SERVICETEKNOTES

TABLE OF CONTENTS

Fig. 3-3. Equipment connections required to adjust Vertical Gain and Calibrator Amplitude.

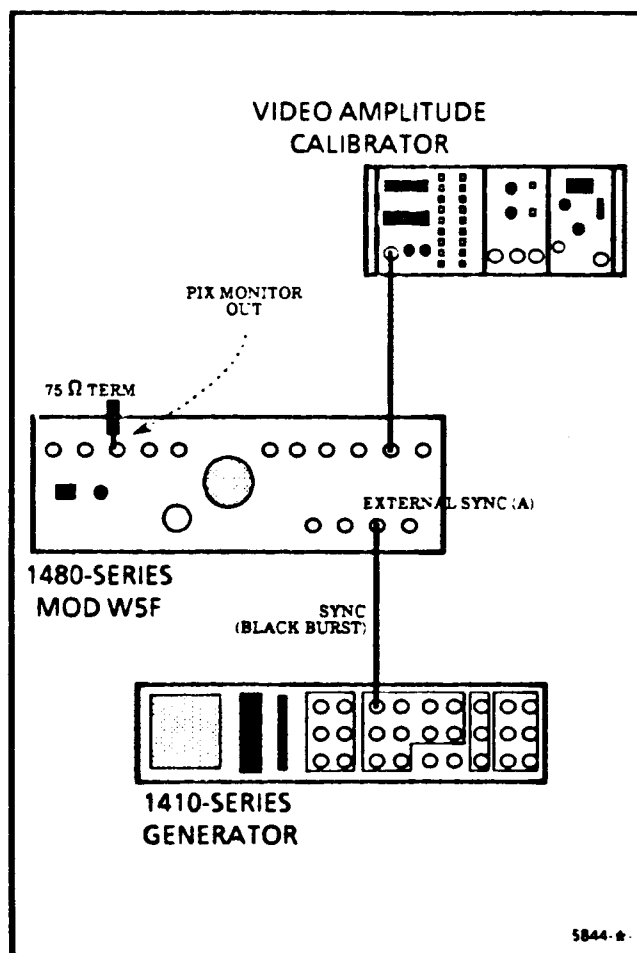
DESCRIPTION**ADJUSTMENT PROCEDURE****CHANGE TO READ:****3. SET CALIBRATOR ACCURACY AND VERTICAL GAIN**

- e. **ADJUST** – Front-Panel screwdriver adjust GAIN for a display amplitude of 140 IRE \pm 1 IRE for NTSC (1.00 V \pm 7 mV for PAL).

Fig. 3-3 Change as shown.

Fig. 3-6. Connecting the *T/2 pulse and bar signal* to adjust Off Screen Recovery.

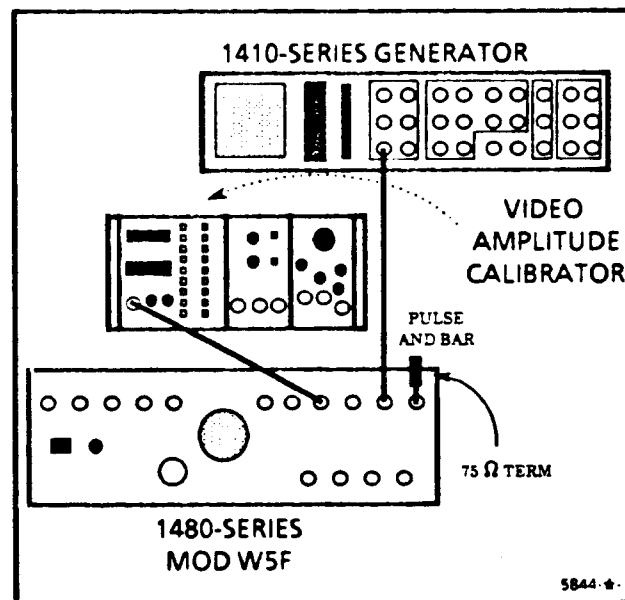
- a. Connect a *T/2 pulse and bar signal* from the Television Signal Generator and the VAC to the 1480-Series VIDEO INPUT A, as shown in Fig. 3-6.

Change Fig. 3-6 as shown.

DIAGRAM 5

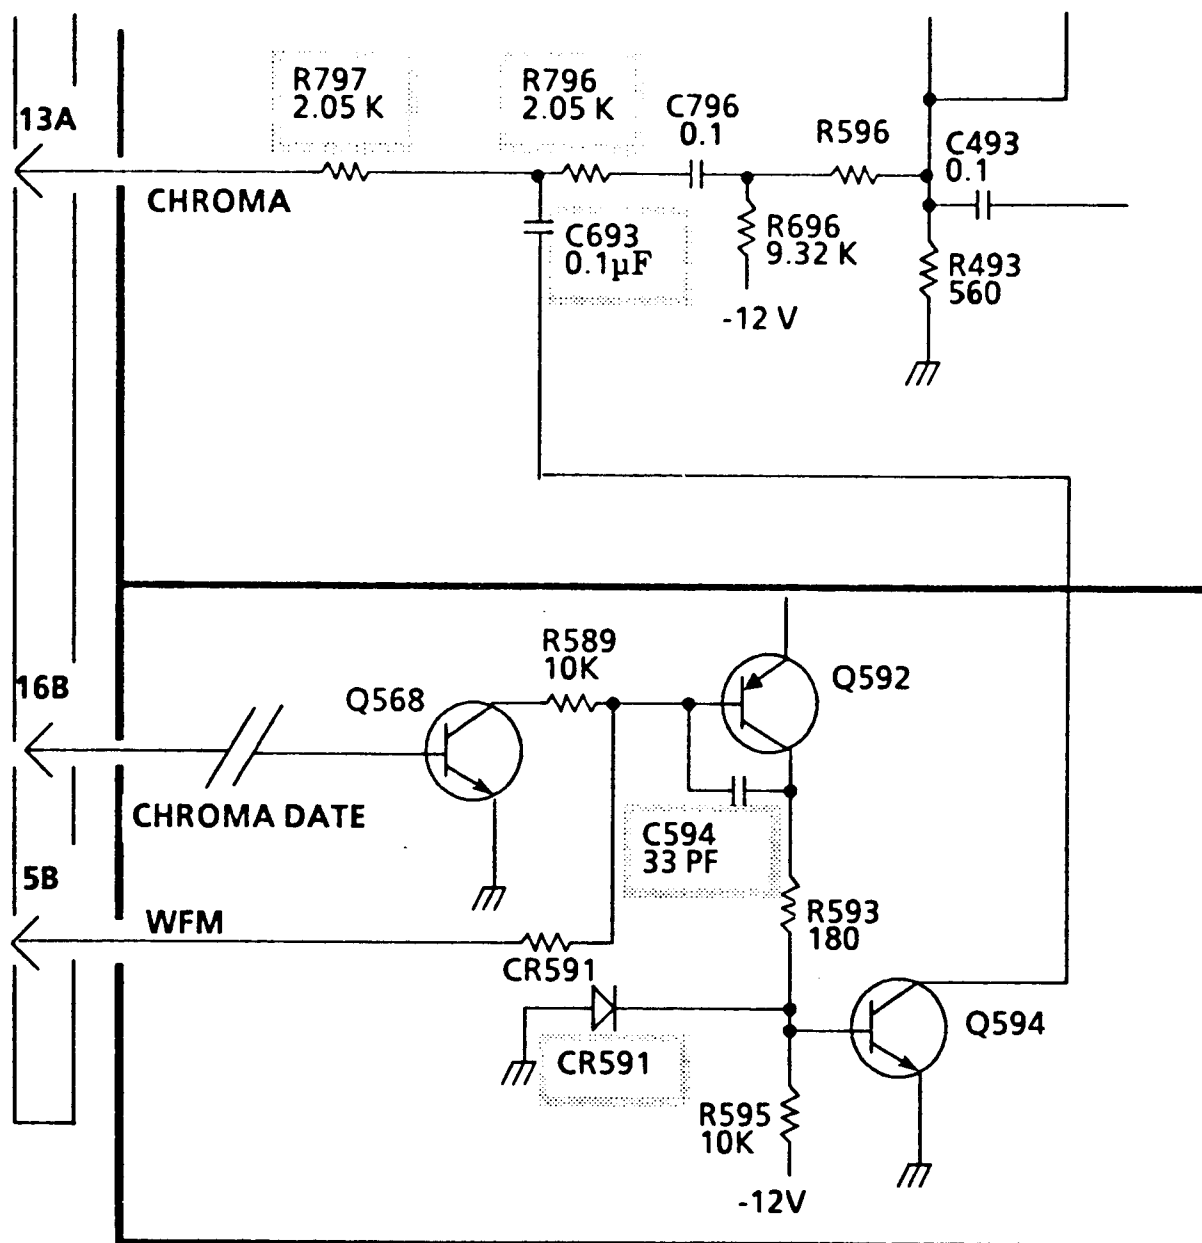
| A5R591 | 315-0512-00 | RES, FXD, FILM; 5.1 K Ohm, 5%, 0.25W (1740, 1741, 1742) | 5 |

Added parts located on diagram 5, see next page.
